SUBJECT: Duke Energy Corporation
Docket No(s). 50-269, -270, -287
Oconee Nuclear Station Units 1, 2, and 3
Supplement to December 16, 1998, LAR
Regarding the HPI System, Removal of the proposed ADV Technical Specification 3.7.4 due to approval of Amendment 309,309,309 dated 1/18/00, and revision of commitment related to implementation of the Configuration Risk Management Program
Technical Specification Change # 98-13

ATTACHMENT 1
REQUEST FOR ADDITIONAL INFORMATION
HIGH PRESSURE INJECTION (HPI) SYSTEM
OCONEE NUCLEAR STATION, UNITS 1, 2, AND 3

ATMOSPHERIC DUMP VALVE OPERATION

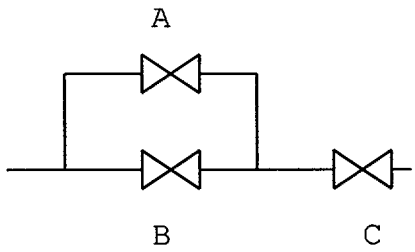
Response to Information needed:

This activity is controlled by an approved written procedure that is pre-staged at the ADVs. The procedure provides a simple, straight-forward sequence for opening the ADVs. The procedure was validated and verified by the EOP project. Procedure enhancements have been made as a part of the EOP effort to ensure optimum performance. The EOP project also improved component labeling, so the ADVs are labeled and easily identified. Mechanical tools are provided to assist the NLOs in opening the valves, if necessary. All three valves are located together outside the Unit control rooms. Two NLOs are dispatched to the ADVs. Two NLOs will provide an independent means of ensuring that the correct valves are opened in the correct sequence. The task of opening ADVs is required to be walked through every two years using a JPM. Credible operator error is lessened by the usage of two NLOs, component identification upgrades, component location, training, and the procedure sequence.

- Open Valve "A"
- Open Valve "B"
- When Directed, Open Valve "C"
